CITY OF PORTSMOUTH
Department of Public Works

ADDENDUM #2

THIS ADDENDUM FORMS PART OF THE ORIGINAL DOCUMENT MARKED:
BID #14-21 Central Fire Station Bathrooms and Kitchen Renovations

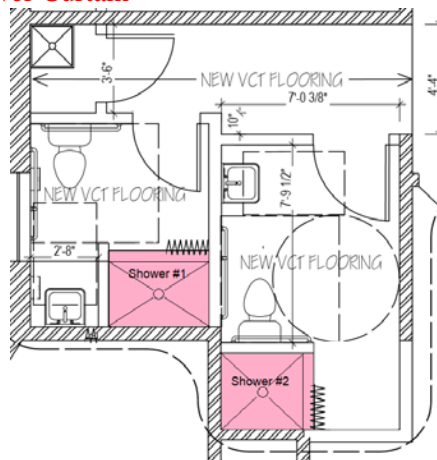
1. RE: Is there to be a hand dryer installed in each bathroom?
A. No hand dryers will be used. Delete Hand dryer specifications in Addendum 1 question 22.
2. RE: scope of work for ceilings.
A. Delete Answer to Addendum 1 question 28. Acoustical ceilings will be installed in the bathrooms
3. Related to Addendum 1, question 31 the existing baseboard is in very poor condition and if being reused we would suggest either replacing the existing piece of baseboard.
A. Replace existing heat strip after relocation.
4. REF: 14-21 EXHIBIT 1 DETAIL 1 & 3, SHOWS CONFLICTING SCOPE OF WORK TO BE COMPLETED TO WHAT IS ACTUALLY ONSITE, PLEASE CLARIFY THE SCOPE OF WORK.
A. Delete answer to Addendum 1, question 17. Replace with: Workscope includes renovating existing conditions to detail in sketch and specs in Addendum 1, question 22.

Frame openings for shower enclosures to receive one each of the following:

1. Shower #1: Best Bath Systems Model 4LRS4832.V2
2. Shower #2: Best Bath Systems Model 4RS3636.V2

Shower accessories to include:

- a. Caulkless Brass Drain with Chrome Screen
- b. 4" Curb height
- c. Curtain Rod/Brackets and Rings
- d. Heavy Vinyl Shower Curtain
